REMARKS

Summary of the Office Action

Summary of the Response to the Office Action

Fig-1

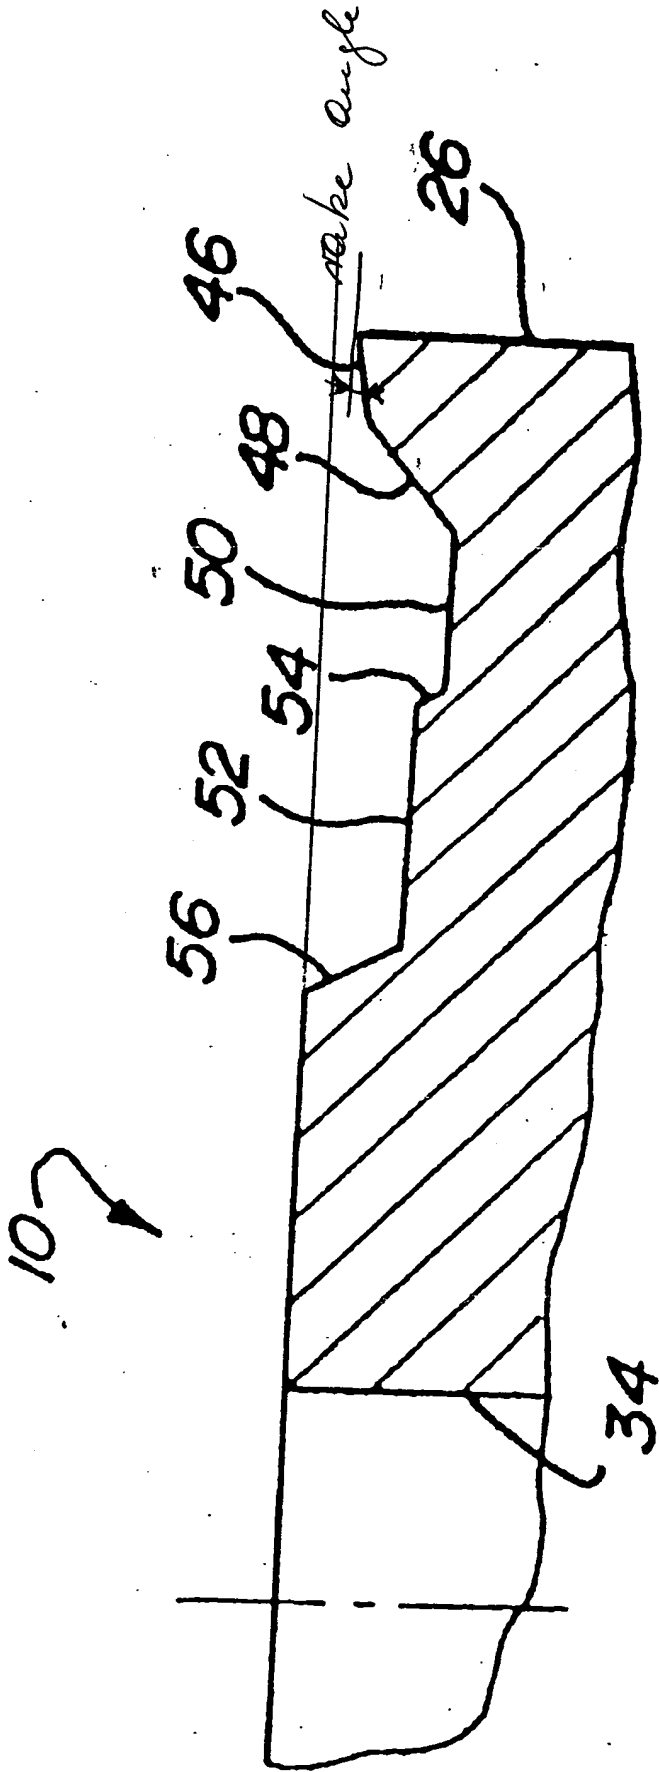
Also, Applicants disagree with the Office Action's position that surface 50 is a completely plain and even surface. Referring to Fig. 1 of Katbi, land 48 is a strip of a constant width. It has the same width all over its length, no matter whether one looks at the corners or at the middle between the corners. Obviously, surface 50 is curved the same way as are cutting edges 30, 32 and so forth.
